DPI Longwall Hydraulic Hazard Workshop

Longwall Pump station review

Presented by Jerry Hessenberger

Figure 1 Model Details

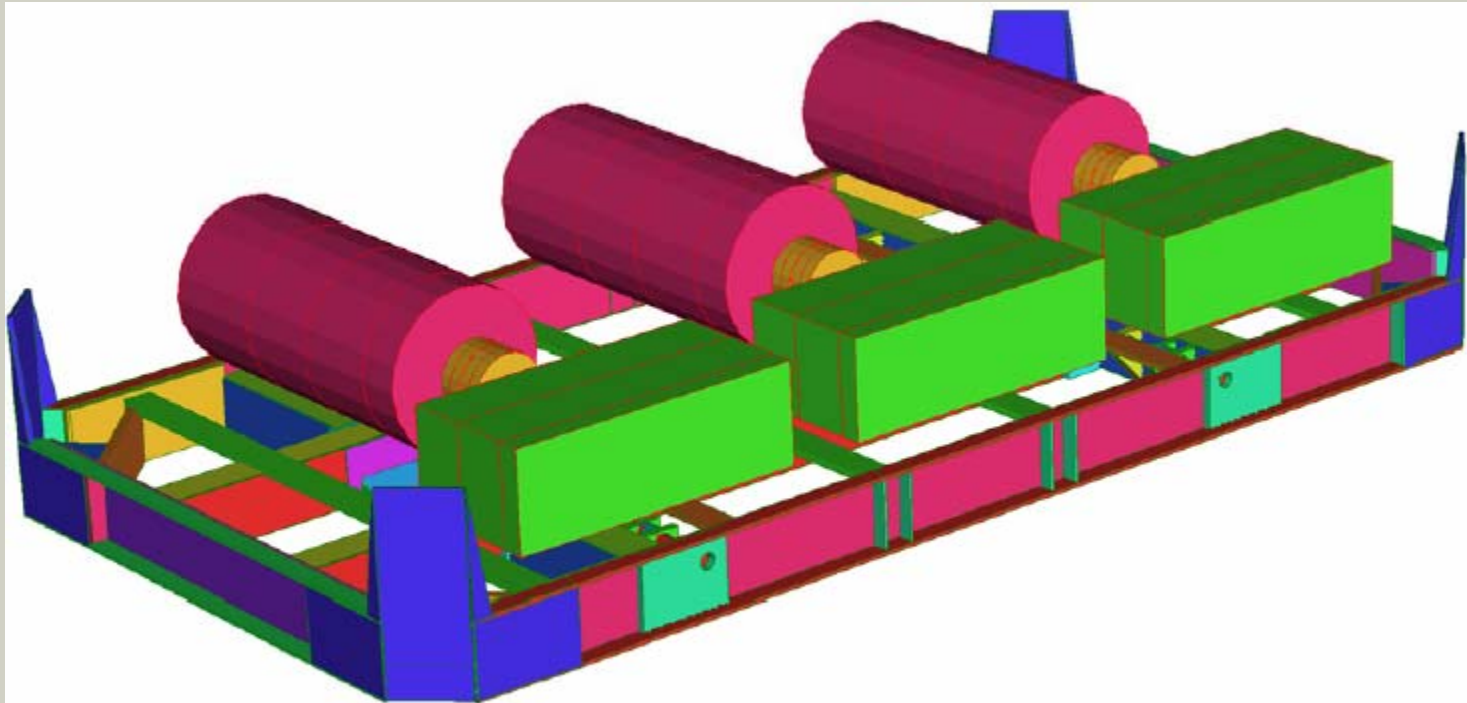
- Modelling to simulate misalignment as a cause of coupling rubber and pump input shaft failures

STRESS RESULTS - Strength

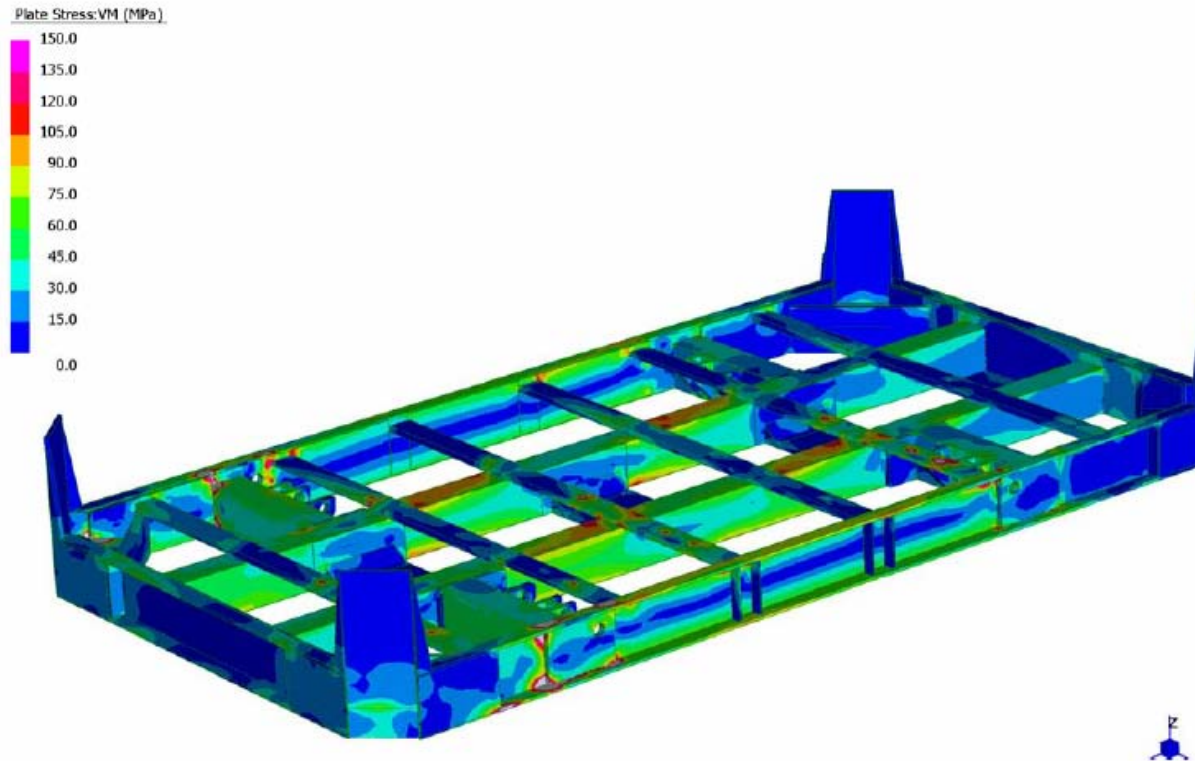
Stress results for an extreme support condition are presented in Figure 2.

- Found isolated regions with stresses above commonly acceptable strength criteria (150 mPa). These local hot spots are not expected to represent strength problems

Stress Results - Fatigue

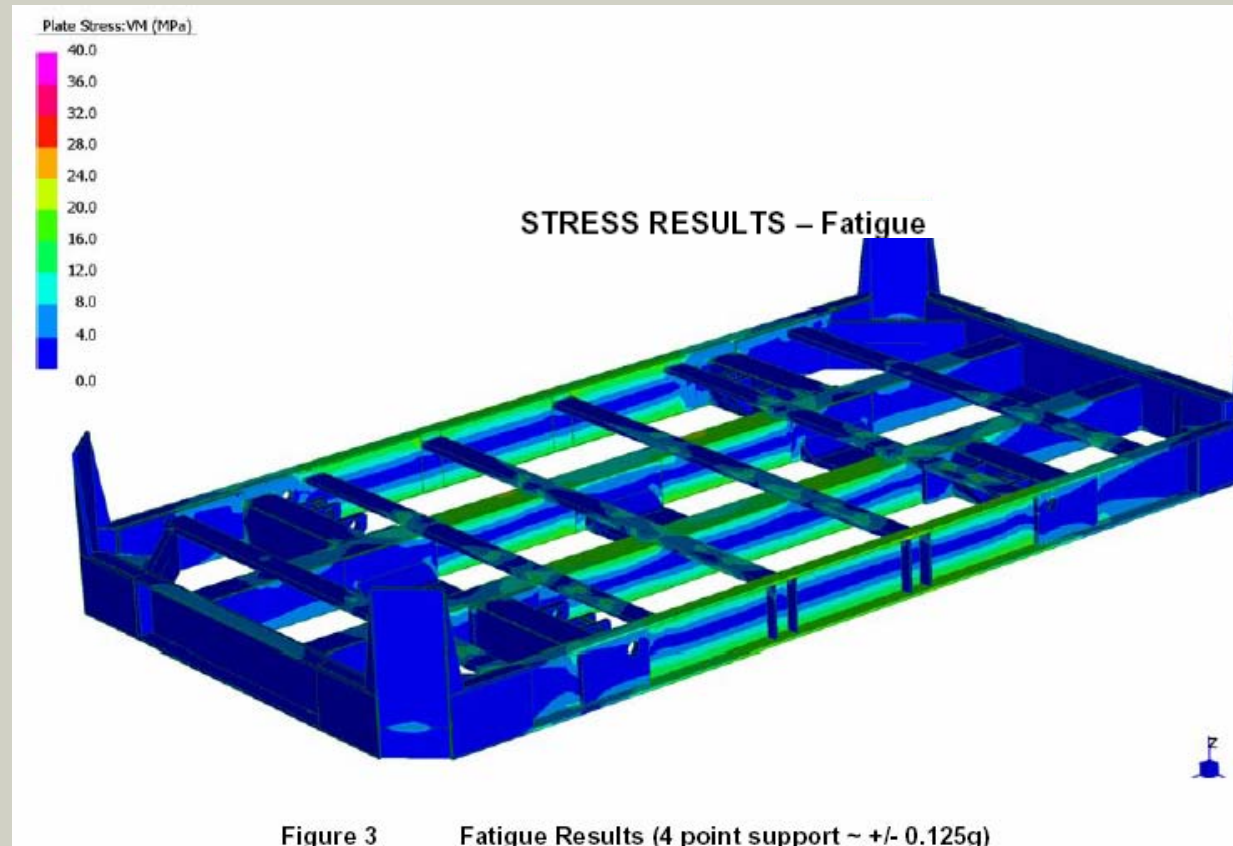
- This loading is based on the approximate operating deflexion observed at West Cliff. There do not appear to be any areas where stress ranges exceed commonly acceptable values for the weld details used (40mPa).

Code 62 Flange FEA

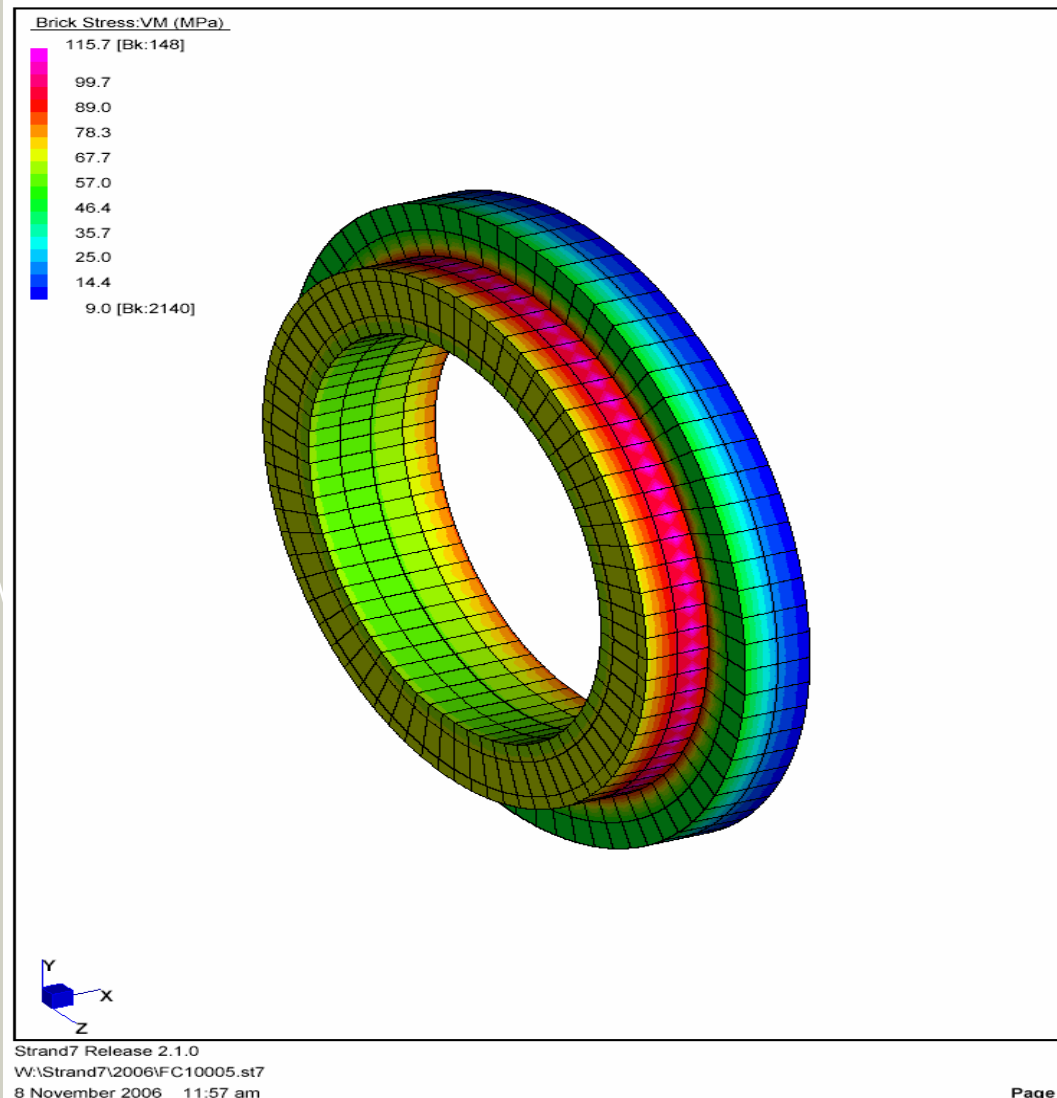
- The end of the SAE Code 62 flange was reviewed using a pressure of 350 bar with a load of 100kg on the end of the "pipe", 300mm from the flange
- Using mild steel flanges - cycling with only hydraulic pressure and occasional external load is OK,
- Cycling with an external load on the flange is not adequate.

Example of WBM's Longwall Hydraulic Supply Modelling

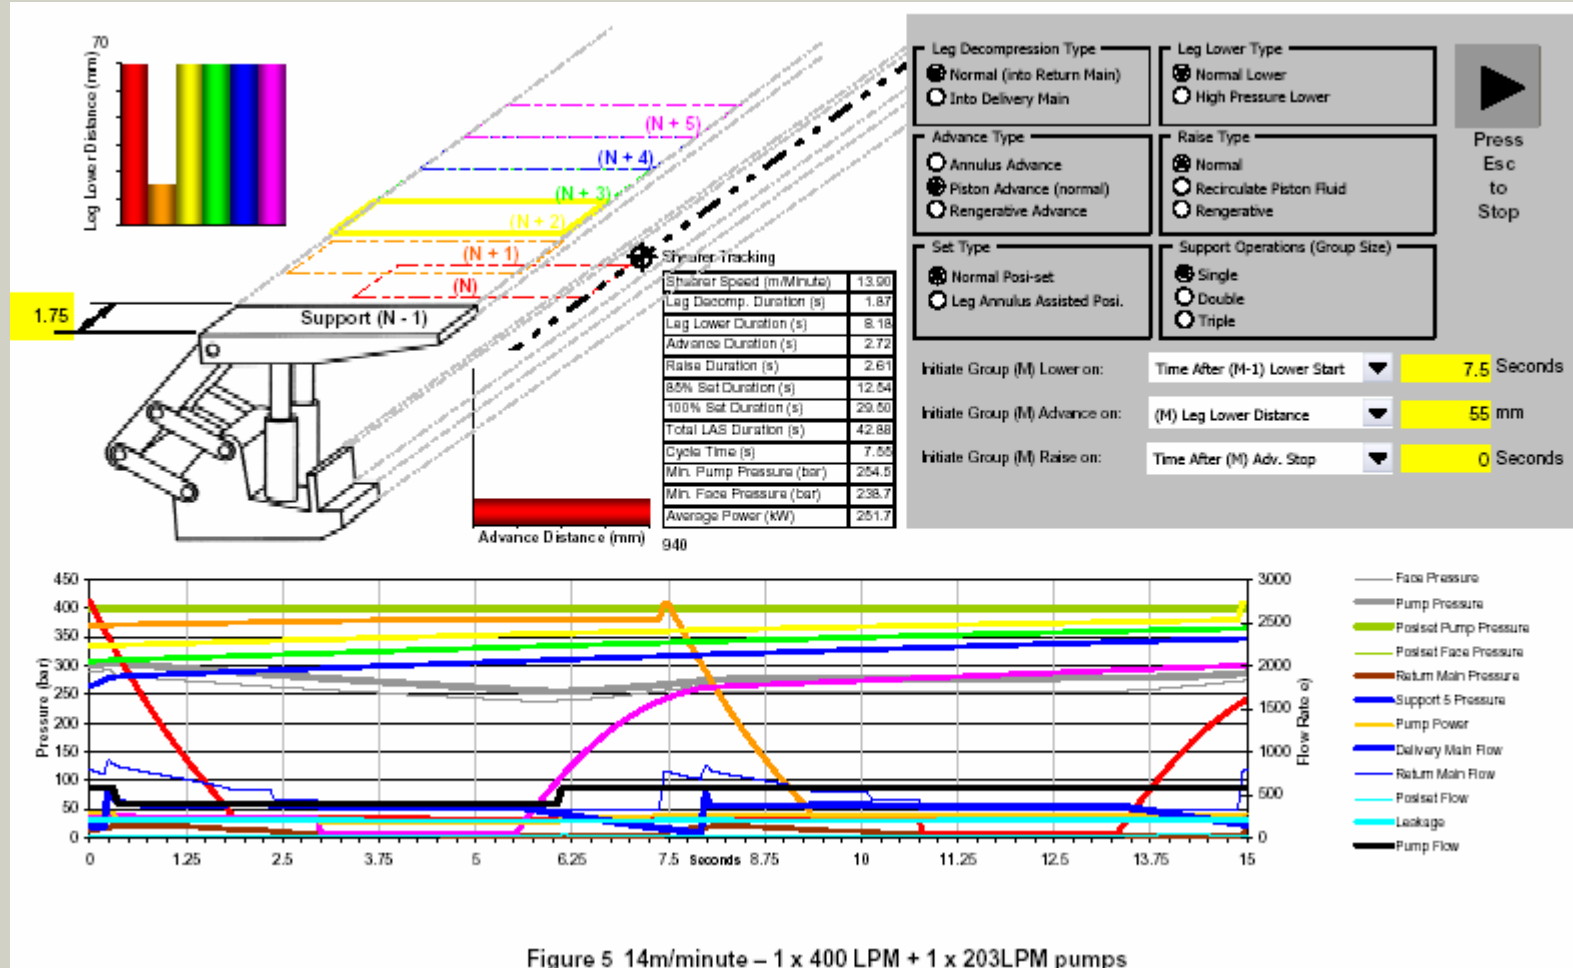
- Suspected unloader delays at Dendrobium should be further investigated.
- Abnormal unloader delay may be the result of unloader malfunction.
- Unloader redesign may be required to improve the unloader performance
- Review option for using smaller 400 l/min pumps to reduce pressure overshoot, cycle times, pressure pulsations and fluid borne vibration, water hammer and shock related problems
